Grove City Area School District High School Renovations

Project No: 23-S43-01

ADDENDUM 2

3/07/2024

2 BASEMENT PARTIAL FLOOR PLAN - MECHANICAL PIPING NEW WORK
Scale: 1/4" = 1'-0"
FIRST FLOOR ELEVATION 1252'-0"

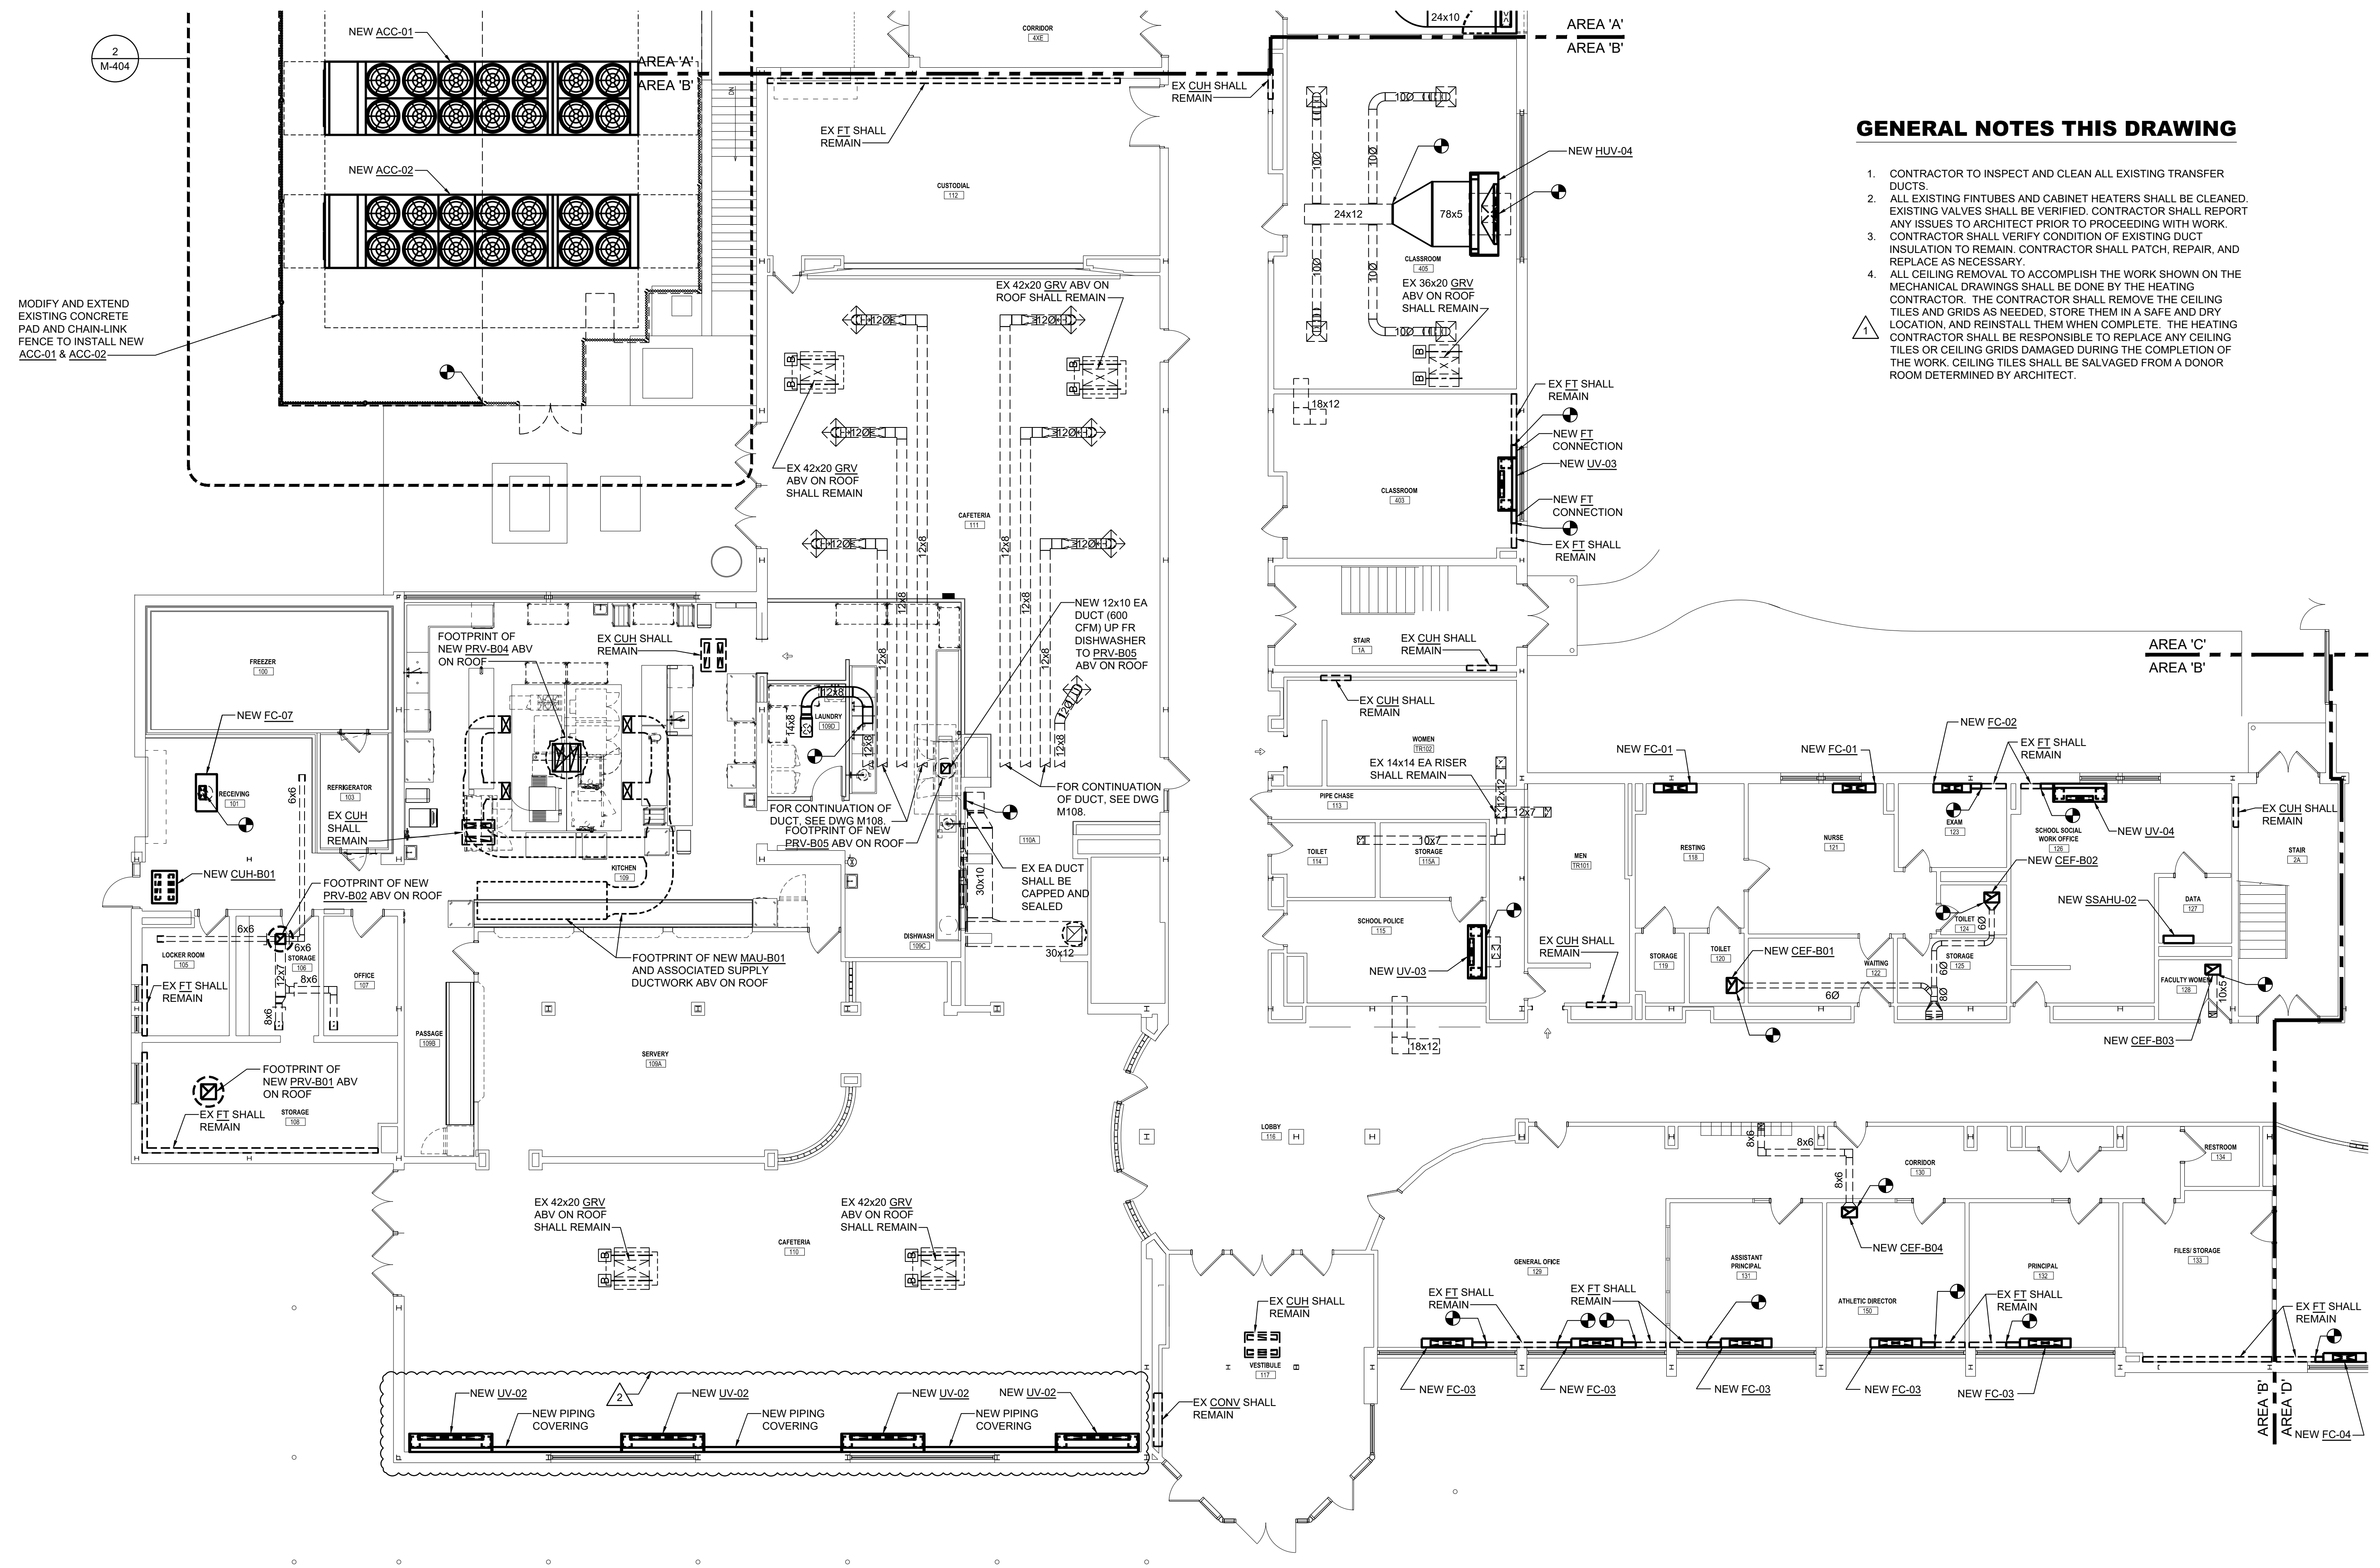
Sheet	Detail	Comments
M100	Basement - New Work	Modified existing 3" piping to new 3" piping
M101	Area A 1st Flr - Ductwork New Work	Updated AHU-AO1 model and duct connections
M102	Area B 1st Flr - Ductwork New Work	Added reconfiguration plan for Unit Ventilator piping coverings in cafeteria units
M105	Area E 1st Flr - Ductwork New Work	Added note for platform modification by HC
M111	Area A 1st Flr - Piping New Work	Updated AHU-AO1 model, modified piping connections, and added new refrigerant piping
M112	Area B 1st Flr - Piping New Work	Modified existing 3" piping to new 3" piping and added reconfiguration plan for Unit Ventilator piping and piping coverings in cafeteria units
M115	Area E 1st Flr - Piping New Work	Added note for platform modification by HC
M116	Area F 1st Flr - Piping New Work	Corrected name of Horizontal Unit Ventilator
M301	Roof Plan - New Work	Added refrigerant piping to ACCU-01

38 NEW TYPE - RE POWER ROOF VENTILATOR
NOT TO SCALE

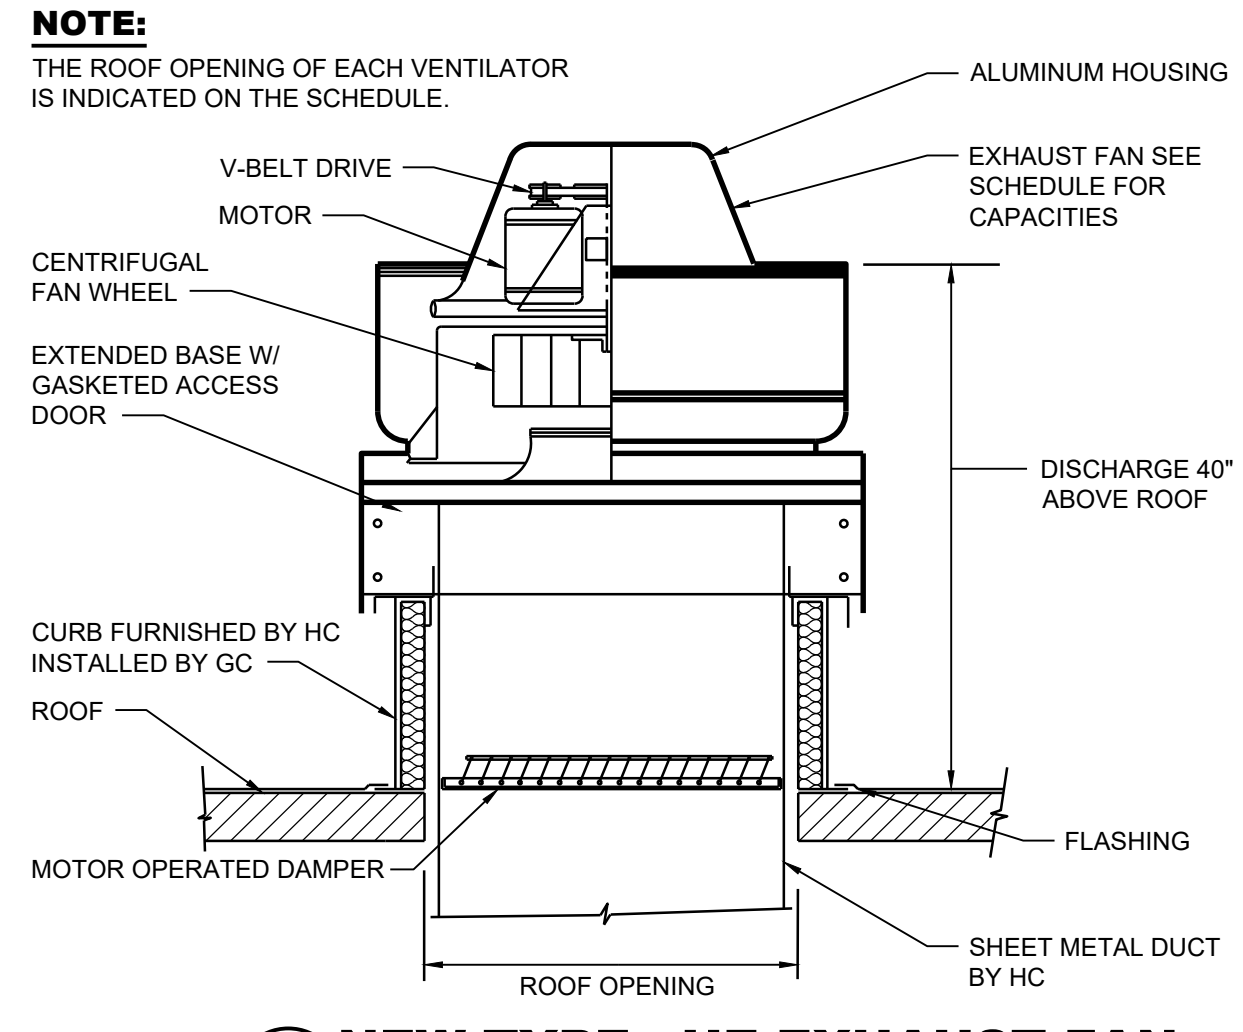
M501	Details	Modified existing PRV details to show new adaptor curbs
M503	Details	Added additional PRV details for new Exhaust Fans
M601	Schedules	Updated DX Air Handler and Unit Ventilator schedules
M701	HW Flow Diagrams	Added primary pumps to boiler loops
MD100	Basement - Demo	Modified existing 3" piping to remain into existing 3" piping to be demoed
MD102	Area B 1st Flr - Ductwork Demo	Added reconfiguration plan for Unit Ventilator piping coverings in cafeteria units
MD106	Area F 1st Flr - Ductwork Demo	Modified louver note in RM 310
MD112	Area B 1st Flr - Piping Demo	Added reconfiguration plan for Unit Ventilator piping and piping coverings in cafeteria units
P101	Area A 1st Flr - Plumb New Work	Added condensate drain piping.
P102	Area B 1st Flr - Plumb New Work	Added condensate drain piping.
P103	Area C 1st Flr - Plumb New Work	Added condensate drain piping.

1 SECOND FLOOR PLAN - AREA 'B' - PLUMBING NEW WORK
 Scale: 1/8" = 1'-0"
 FIRST FLOOR ELEVATION 1252'-0"

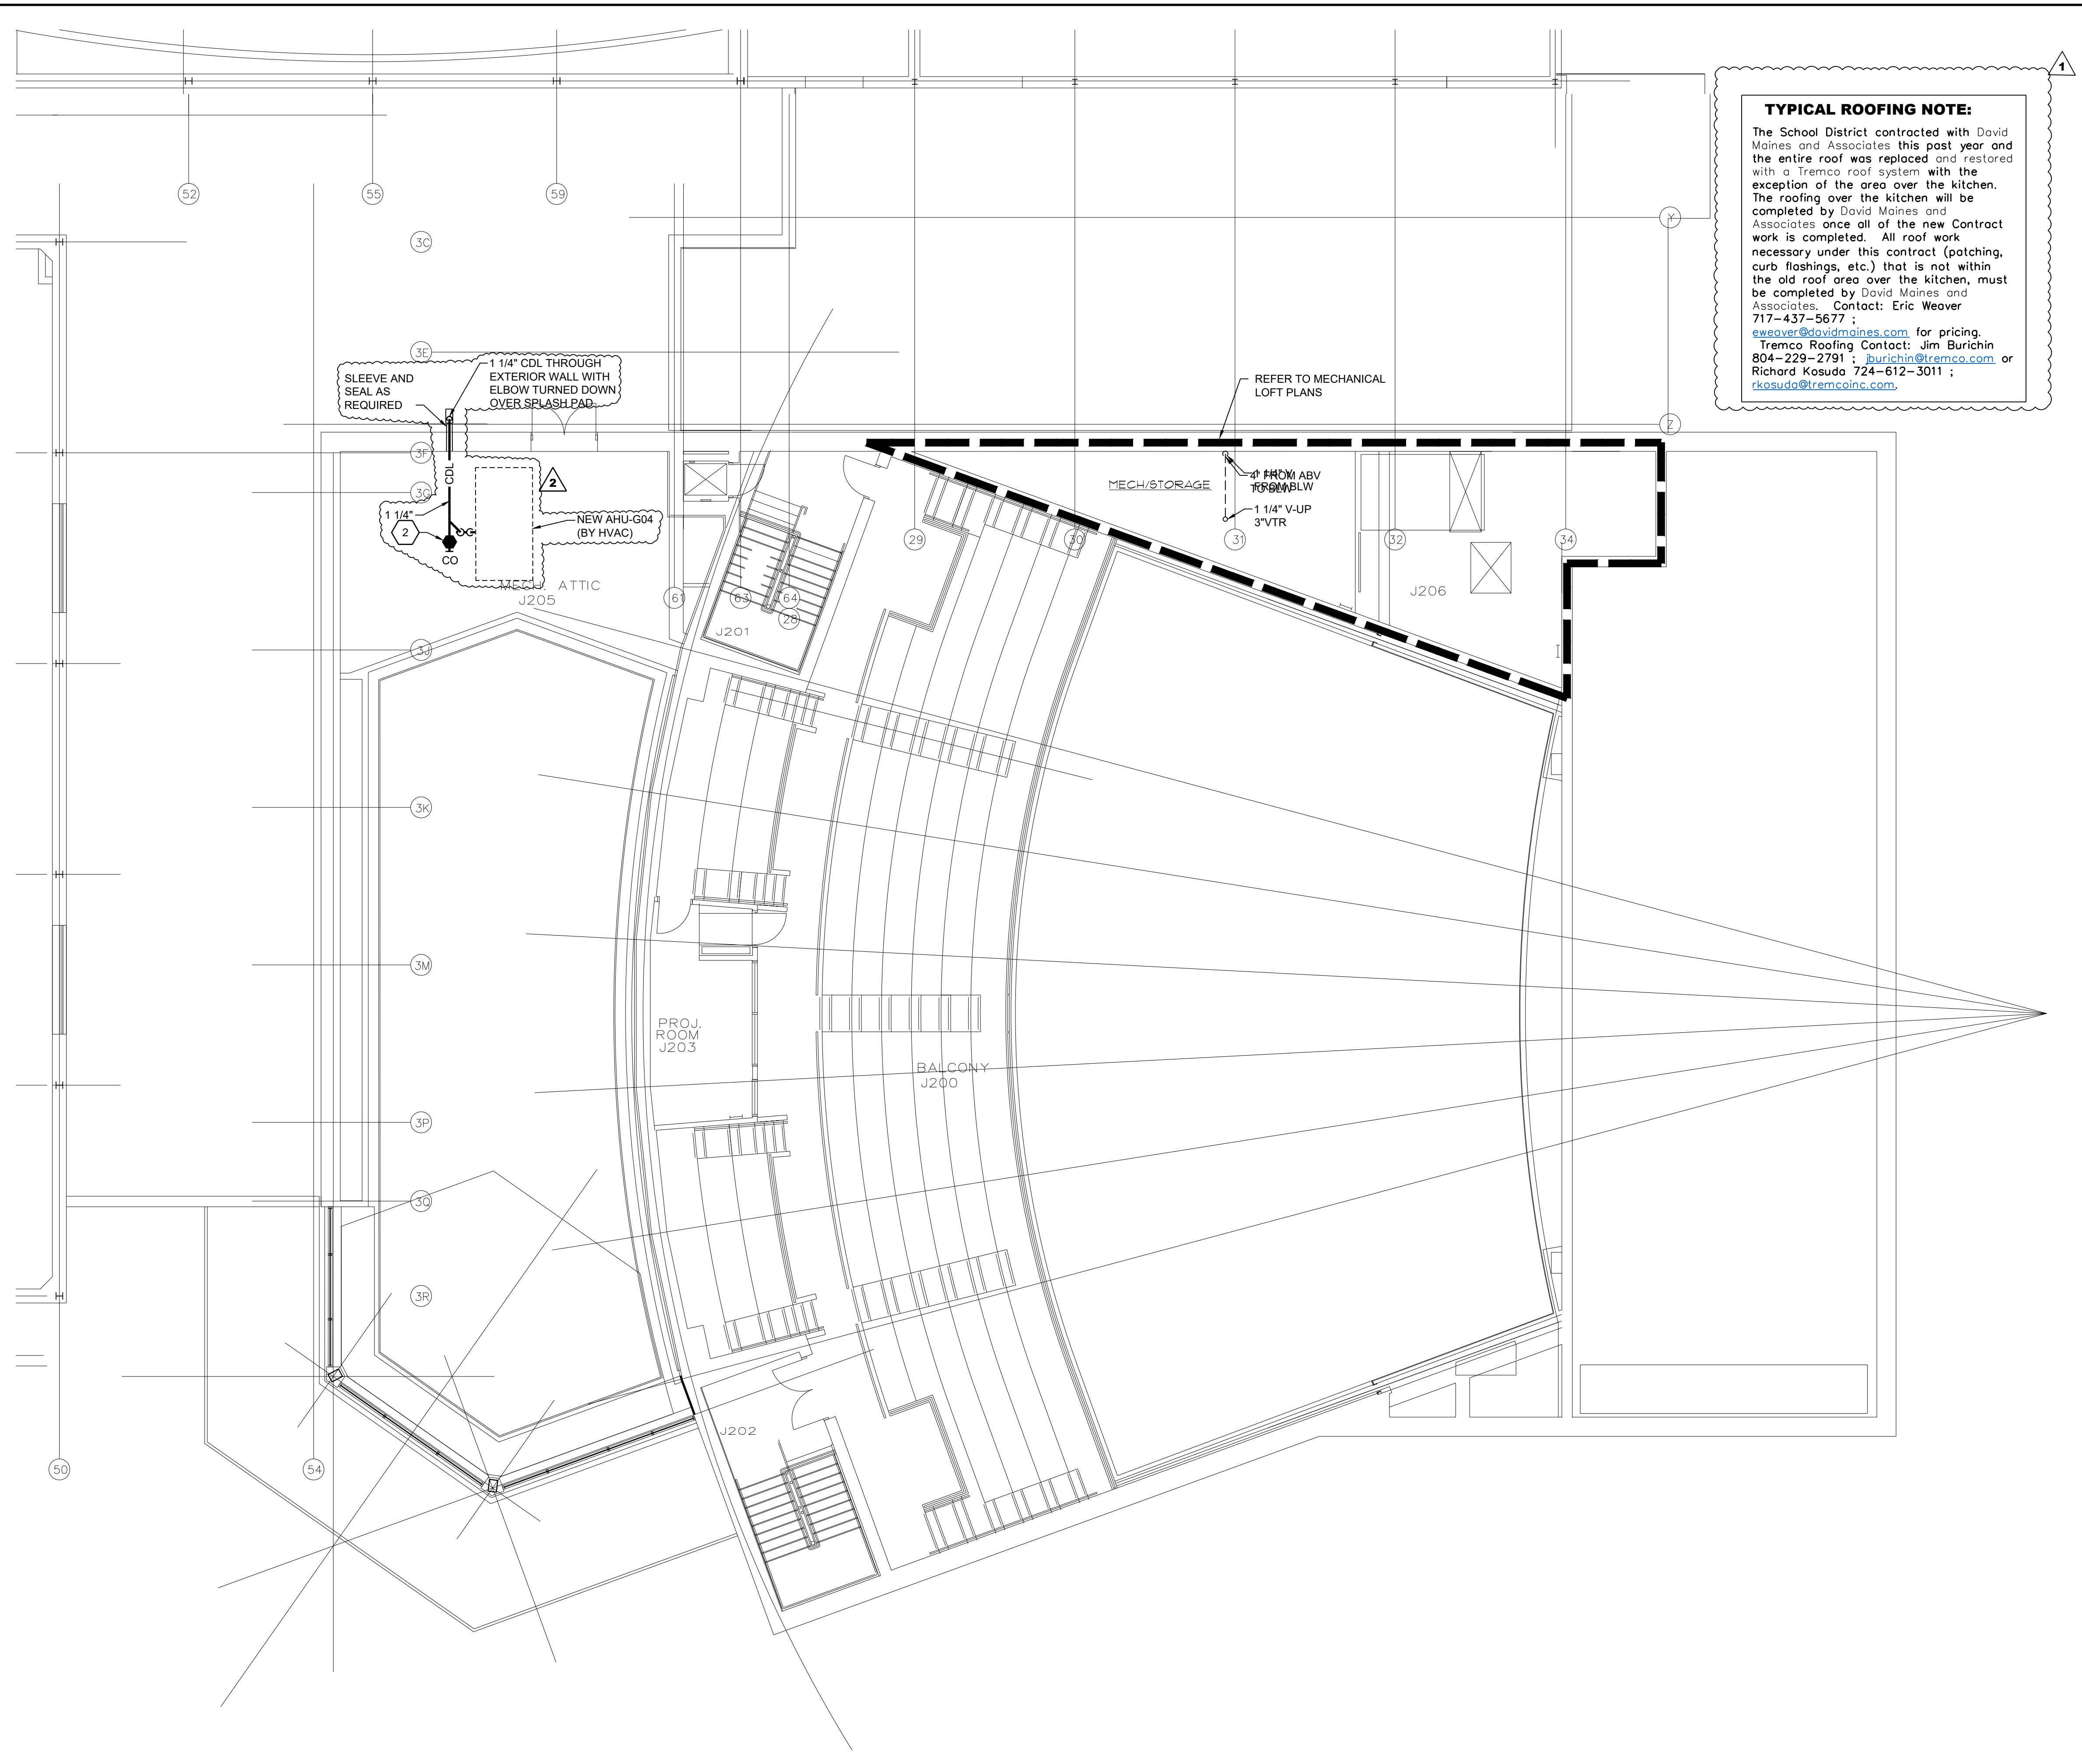
P108	Area B 2nd Flr - Plumb New Work	Added condensate drain piping.
P110	Area E 2nd Flr - Plumb New Work	Added condensate drain piping.
P112	Area G 2nd Flr - Plumb New Work	Added condensate drain piping.
